**PROJECT: Smithsonian Institution,
National Zoological Park Seals & Sea Lions Exhibit
LSS Building – Construction Phase**

ITEM SUBMITTED: Electric Snow Melt System

SPECIFICATION SECTION: 26 4400; 16A-0024-264400-1

SUBMITTAL STATUS: Approved as Noted

SNOW MELTING	DRAWING NUMBER SM-1
--------------	------------------------

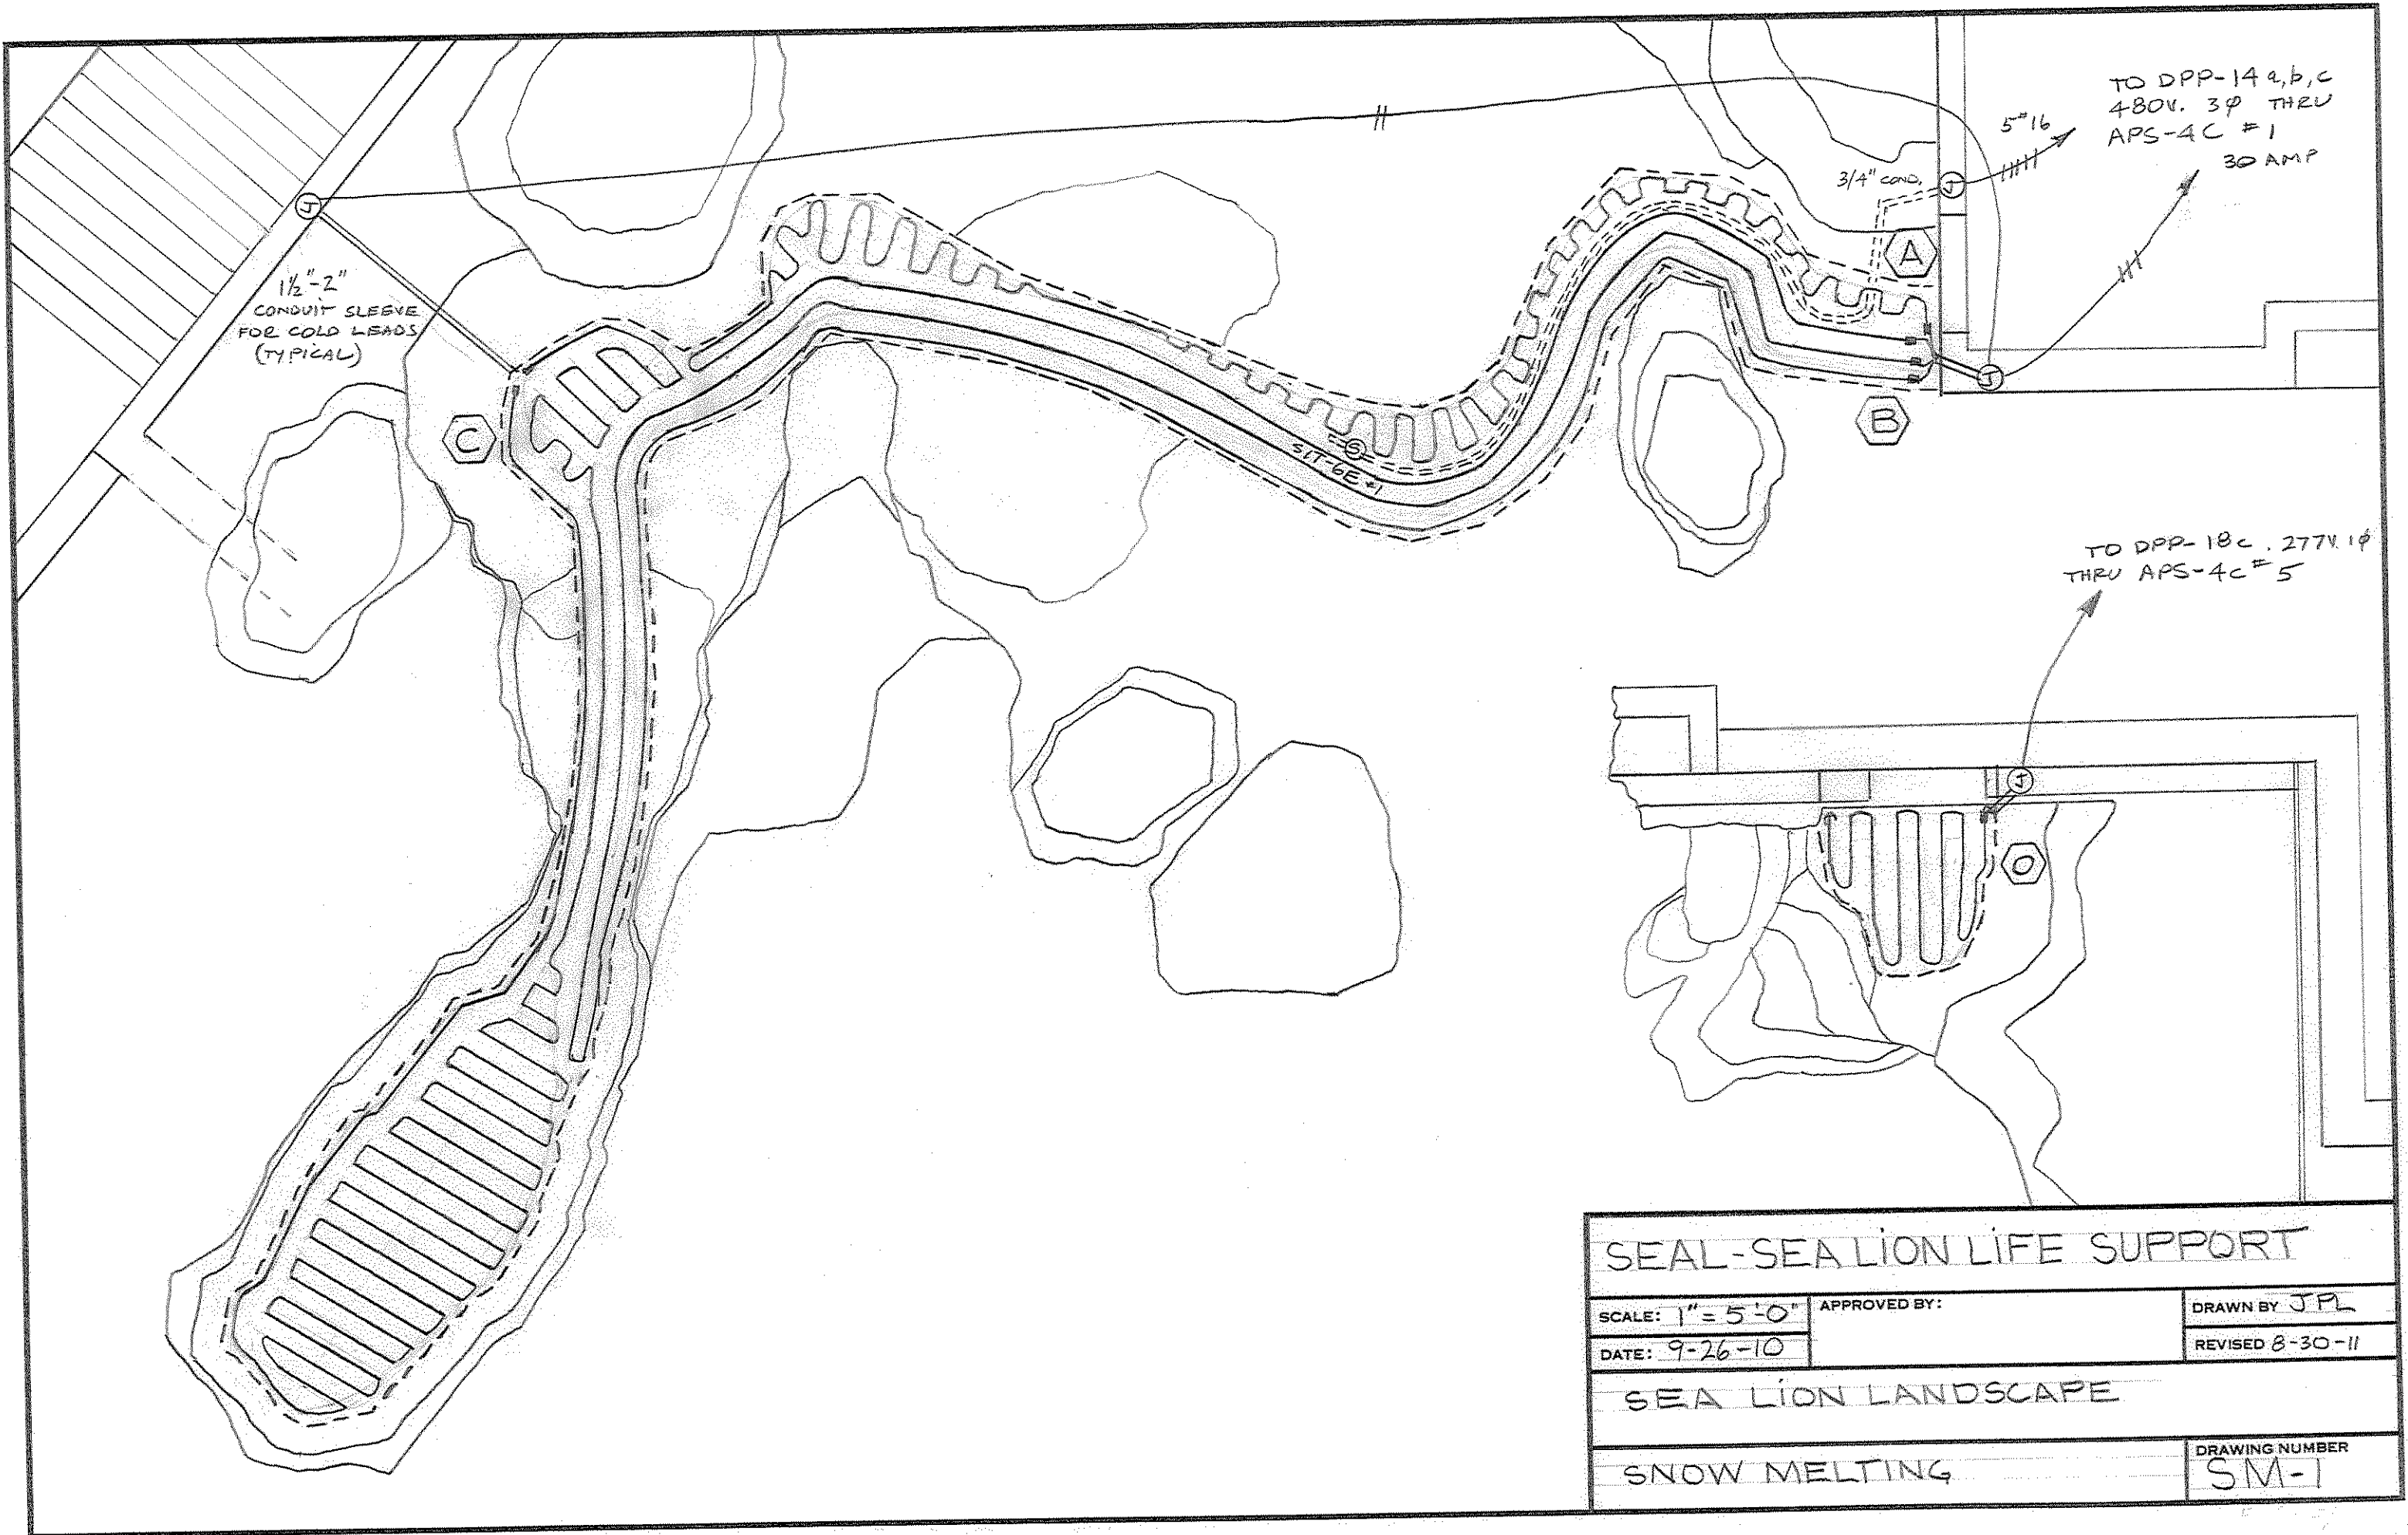
- 1. All sketches: The system layout sketches are not clear as to the wiring of the precipitation sensors and high-temperature limit sensors. Per manufacturer's recommendations, the high-temperature limit sensor wiring should not pass through the precipitation sensor assembly. Instead, it should be run in a separate conduit. This could be run to a common junction box, and then run back to the building controllers along with the precipitation sensor wiring.**

- 4. Sketches SM-1 & 2 : Coordinate the location of the precipitation sensors with SI NZP. Sensors should be positioned with proper exposure and proper elevation in relation to the surrounding surfaces and exhibit elements.**

SEAL-SEALION LIFE SUPPORT		
SCALE: 1/4"=1'	APPROVED BY:	DRAWN BY JPL
DATE: 9-26-10		REVISED 8-30-11
SEALS HOLDING POOLS		
SNOW MELTING		DRAWING NUMBER SM-4

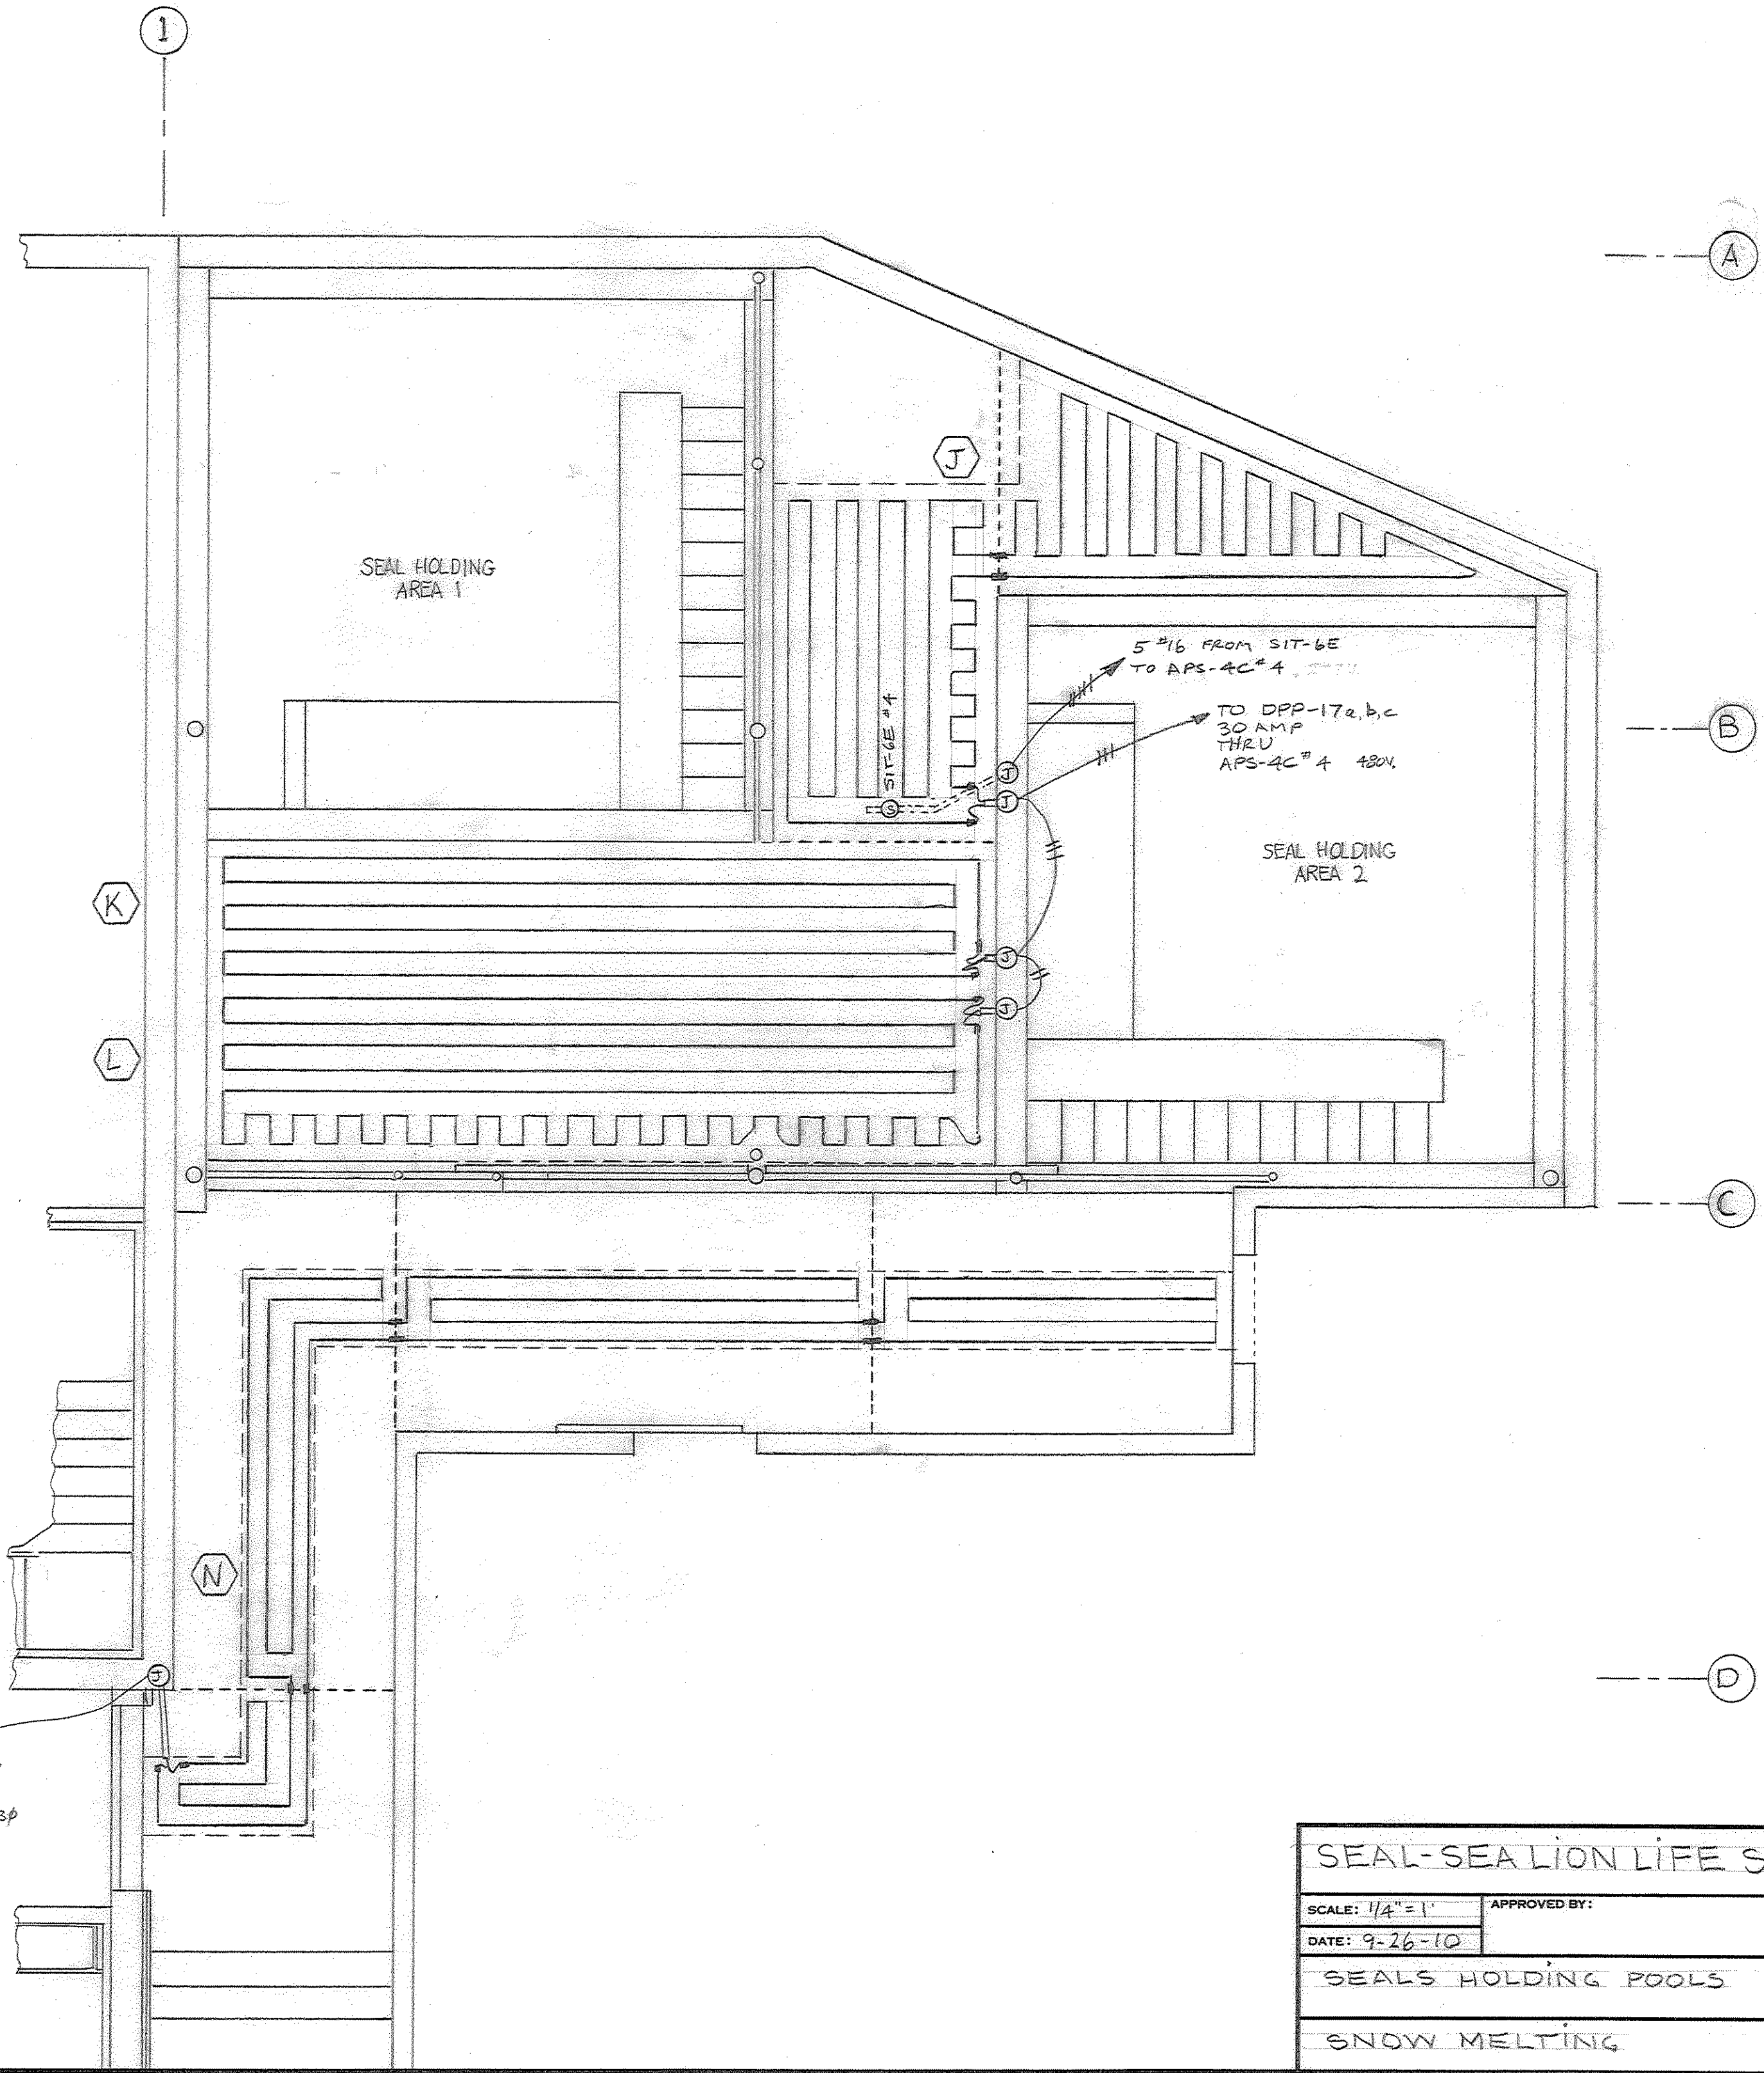
- 2. Sketch SM-5: The precipitation sensor in the Animal Recovery should be eliminated. Manual control of this zone is acceptable.**
- 3. Sketch SM-4: There is no precipitation sensor located in the Seal Holding or Seal Passage areas. There is concern the system will not operate optimally in these zones without a dedicated sensor. We suggest that the sensor eliminated from Animal Recovery be installed in the Seal Holding area.**
